DOCUMENT 009113.01 – ADDENDUM 01

- A. Project Name: Middle Park High School Summer 2026 Renovation
 - 1. Owner: East Grand School District No. 2
 - 2. Owner Project Number <Owner Project Number>.
 - 3. Architect: Hord Coplan Macht (HCM).
 - 4. Architect Project Number: 222000.30

1 FIRST FLOOR PRESS BOX PLAN - ELECTRICAL
1/4" = 1'-0"

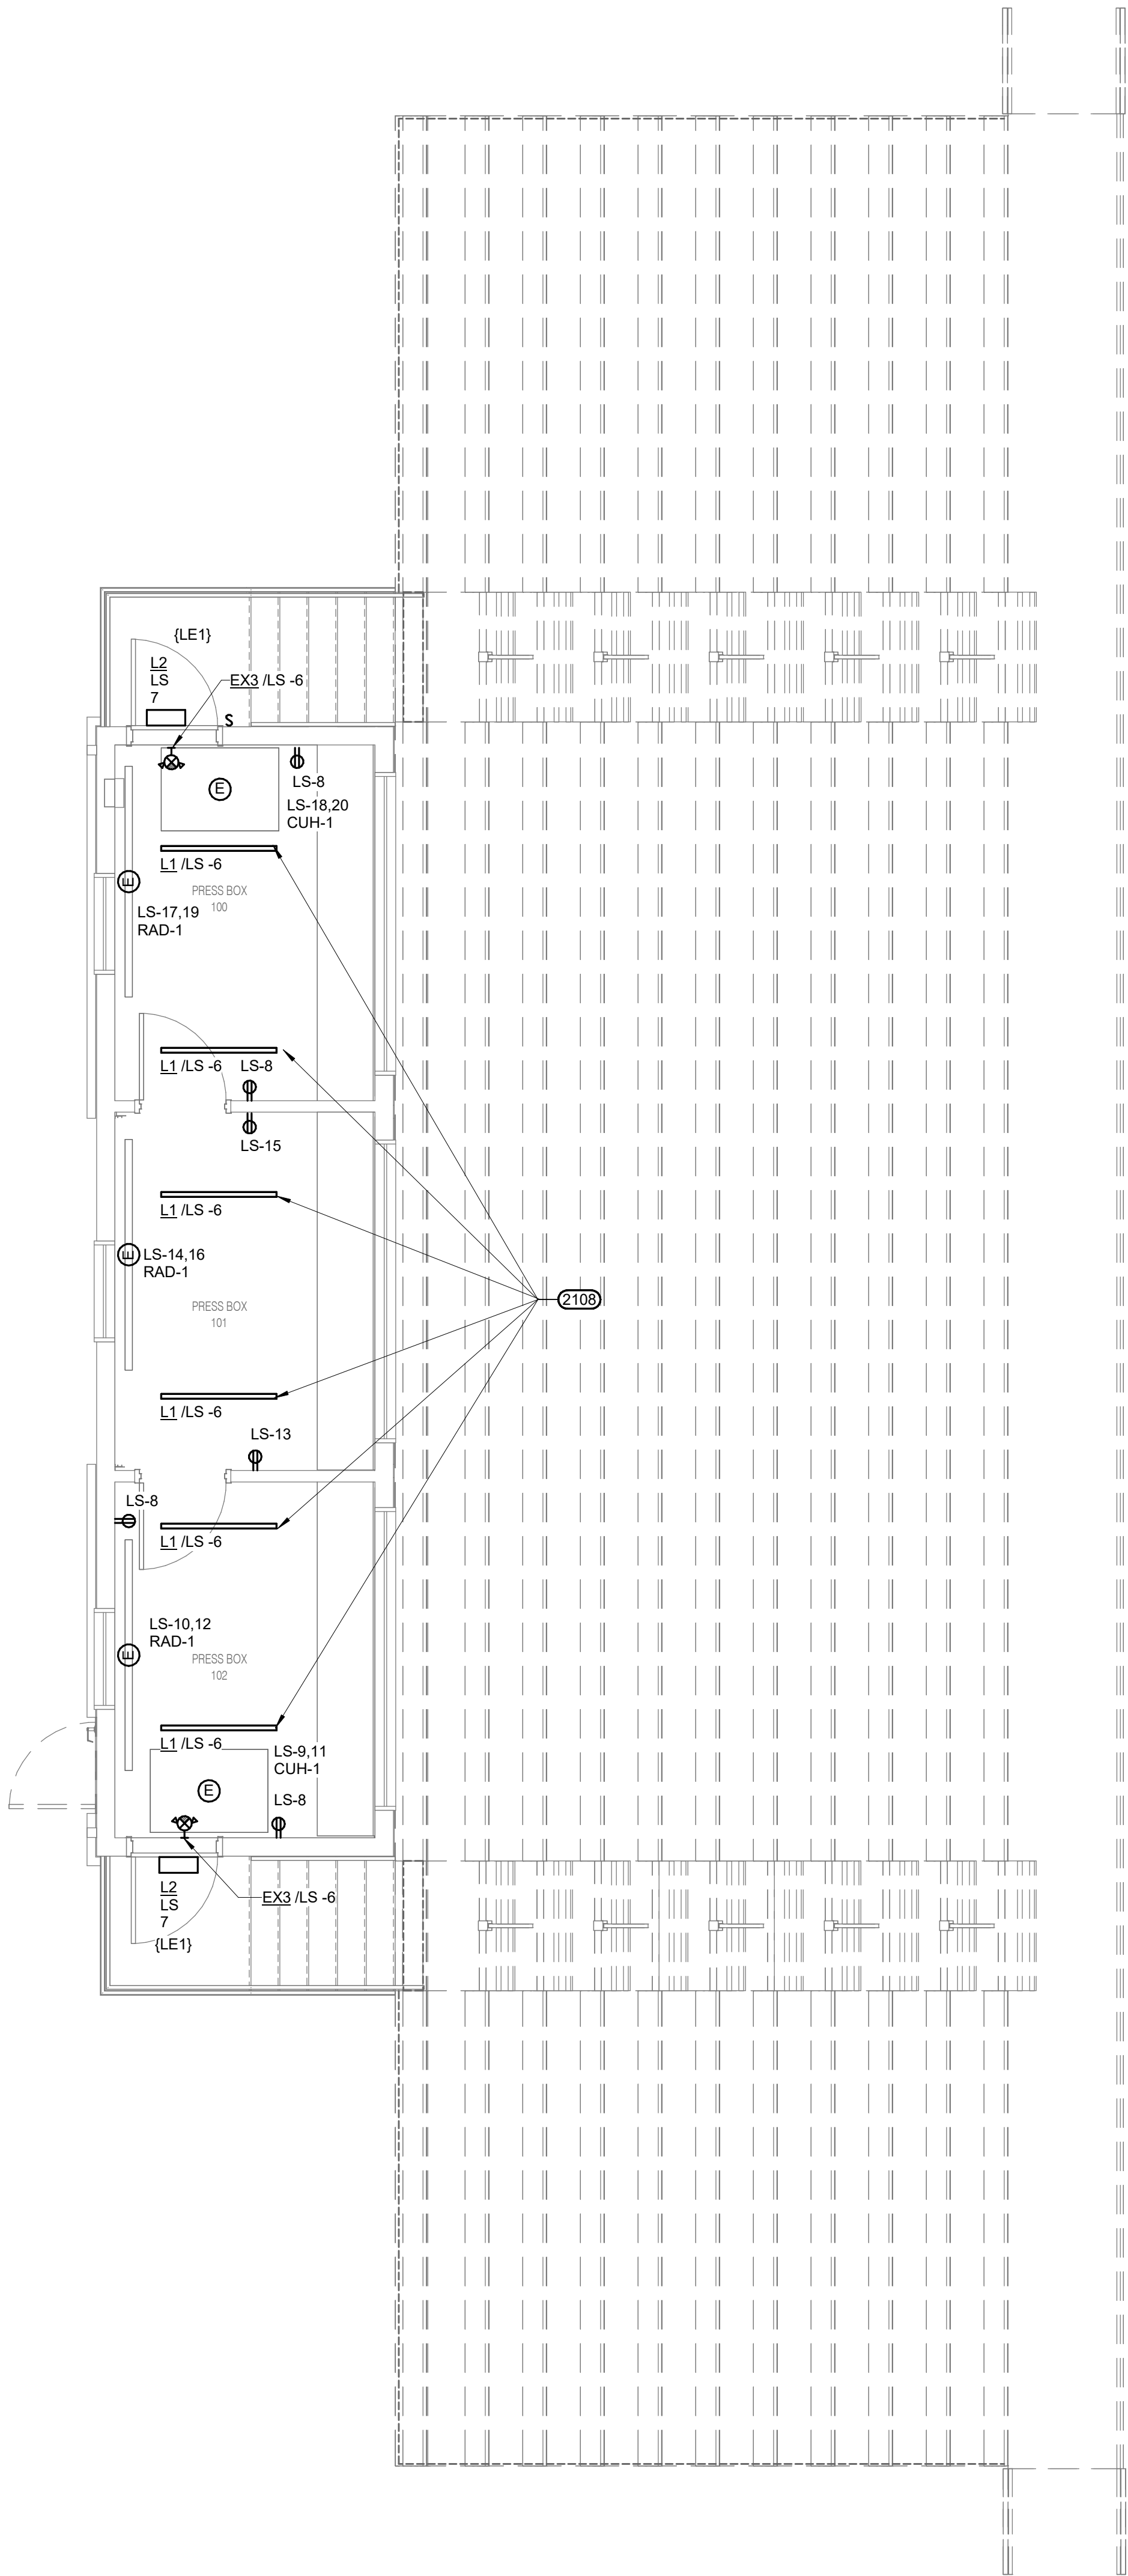
2. Revise Panel LS and Press box, Partial Electrical One-Line Diagram.
 3. Add motorized gate operator electrical connection described in keynote 2247.

- a. Response: Detail 1 on sheet E-511 revised to indicate location of existing pole.
7. Comment: Automatic lift gate to the west side of the new press box does not show any power being fed to it on the electrical drawings. Please provide the power requirements and existing power tie-in location for this gate.

- a. Response: Keynote 2247 added to sheet E-100 for gate power.

NEW MOTORIZED GATE OPERATOR, PROVIDE DEDICATED 120V 20A CIRCUIT. COORDINATE WITH MANUFACTURER ON ROUGH-IN REQUIREMENTS INTO BASE/LEAVEOUT. WIRE WITH 2#12 + #12G IN 3/4" C. REFER TO SHEET A-100 FOR LOCATION (APPROXIMATELY 130" WEST OF PRESS BOX).

1 TECHNOLOGY SITE PLAN

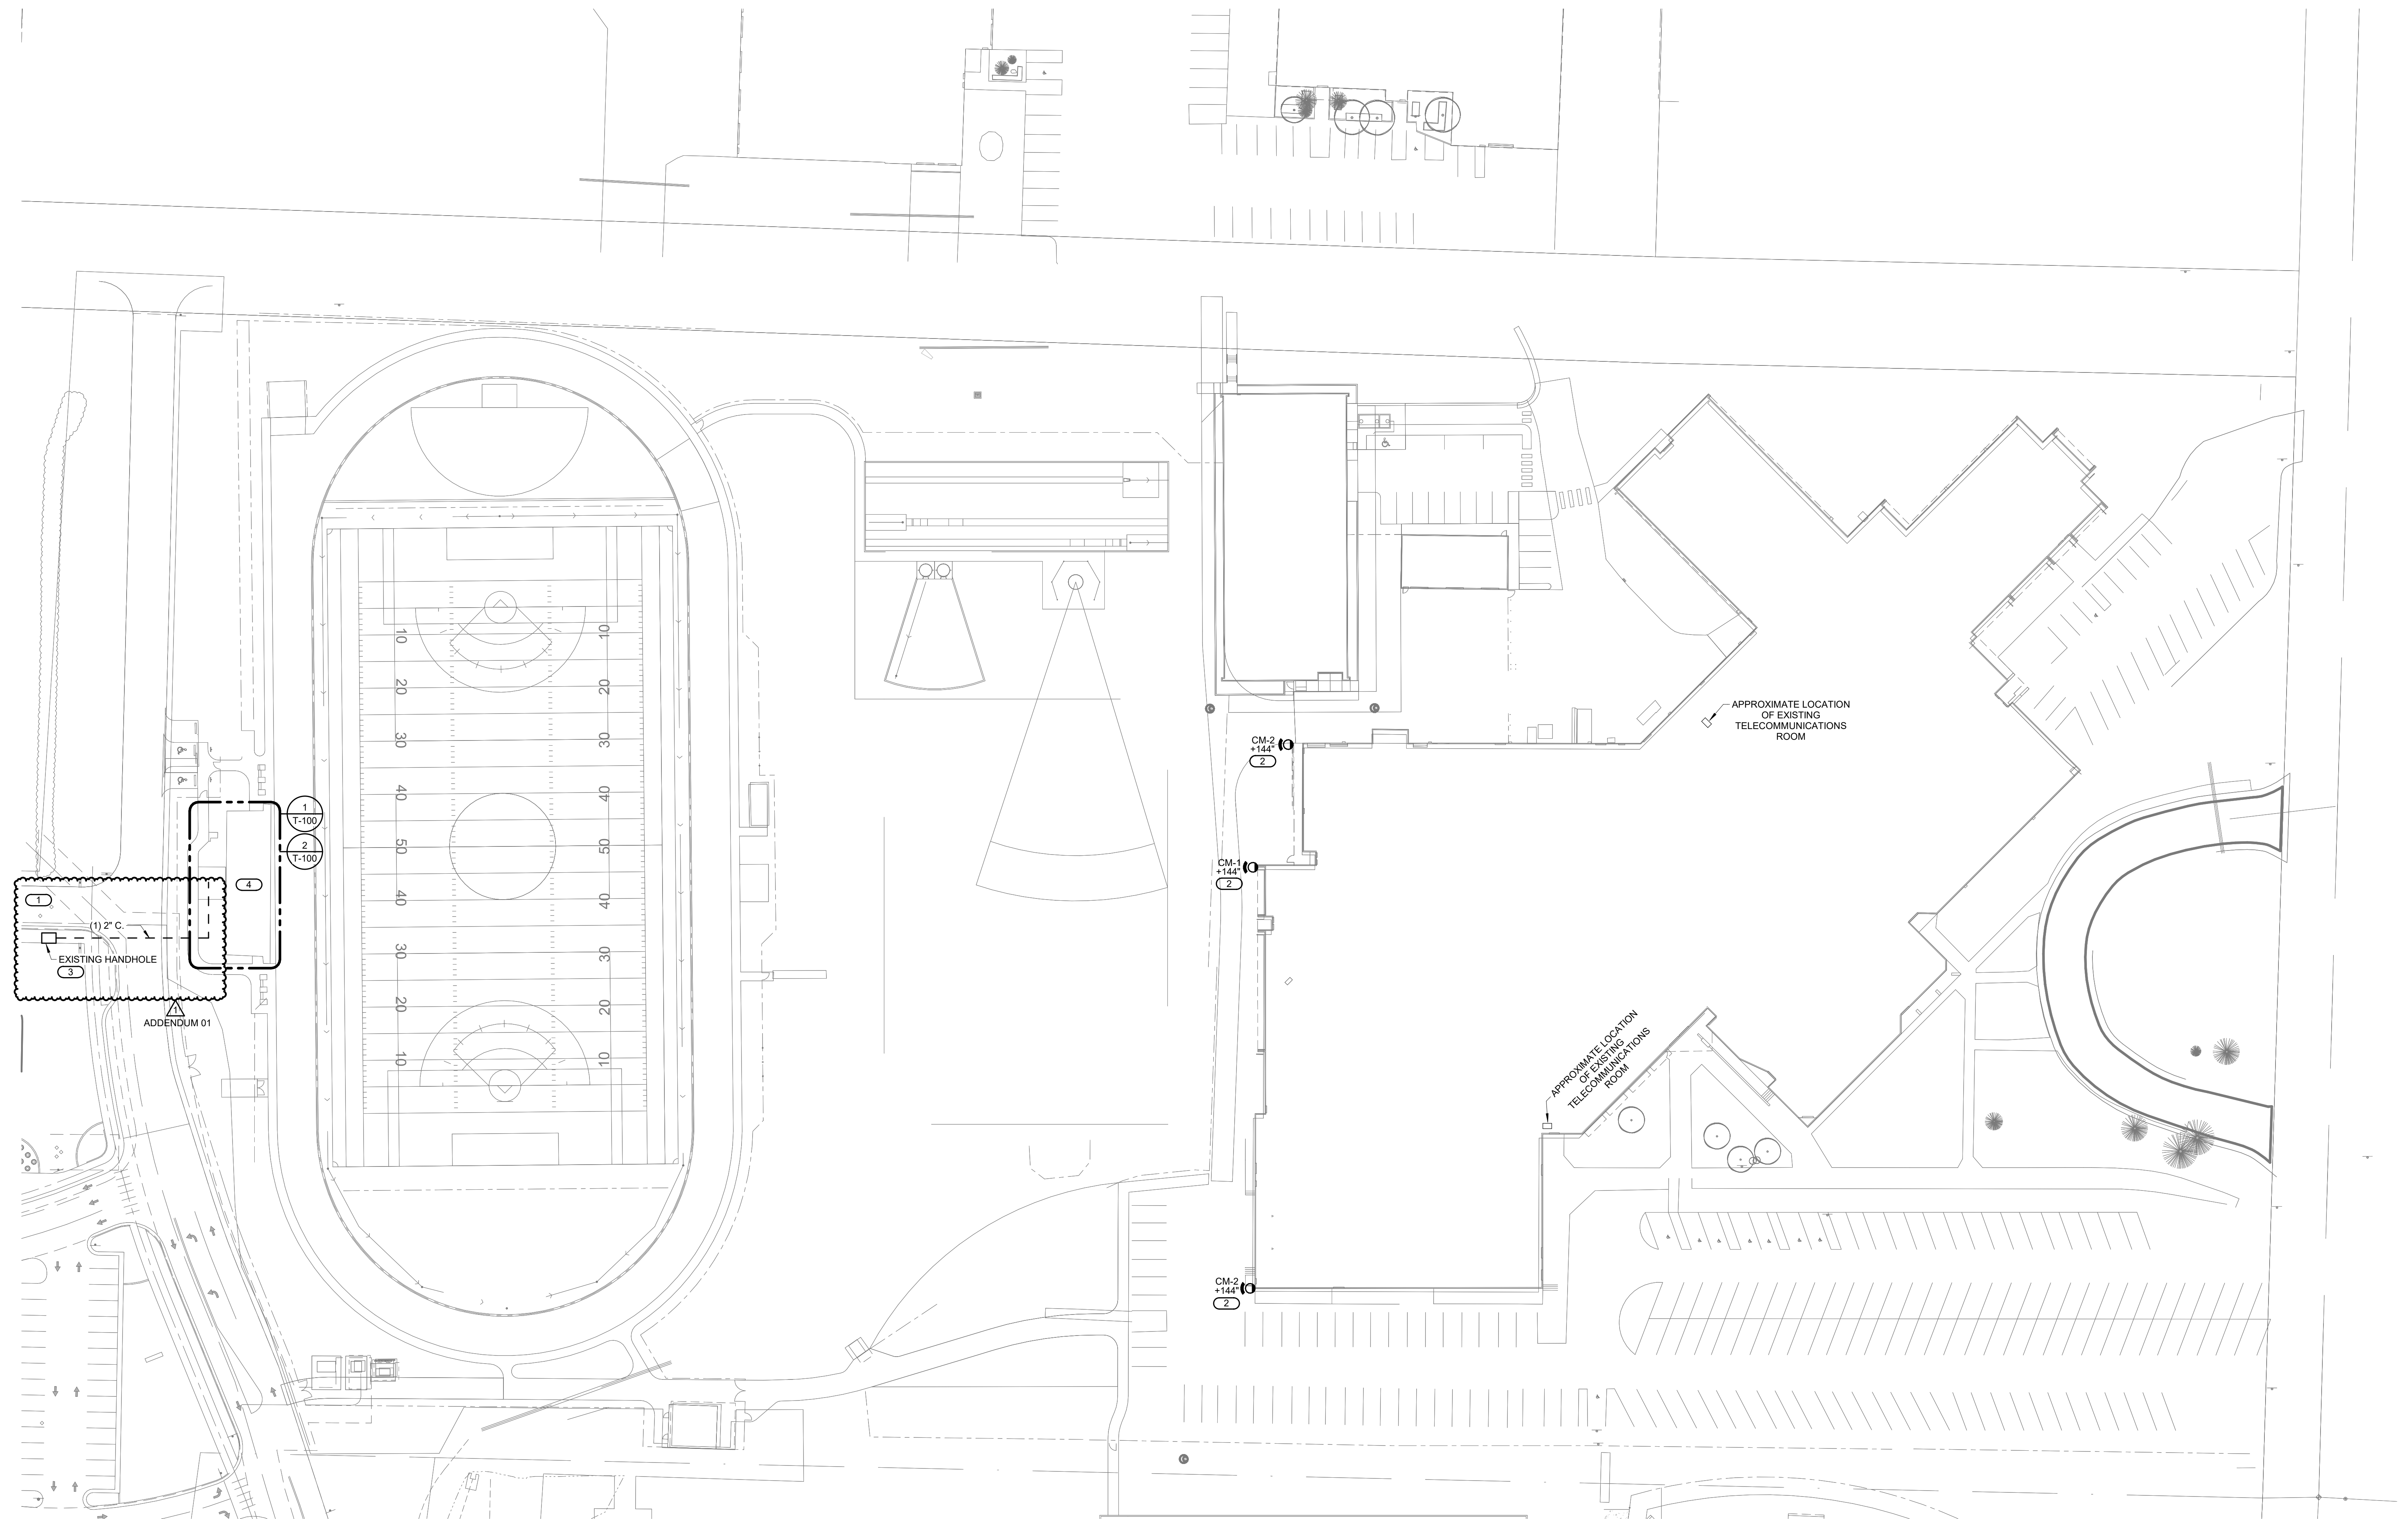
5. Add disconnect schedule.
- K. Revision to sheet T-000.
1. Revise sheet notes to clarify that new press box will be supported by fiber connection instead of wireless bridge.

2. Add 2" conduit between existing Granby ES handhole and new press box to support fiber connection.
 3. Add note for contractor to provide alternate for reestablishing the microwave antenna connection that previously supported the old press box in the new press box.
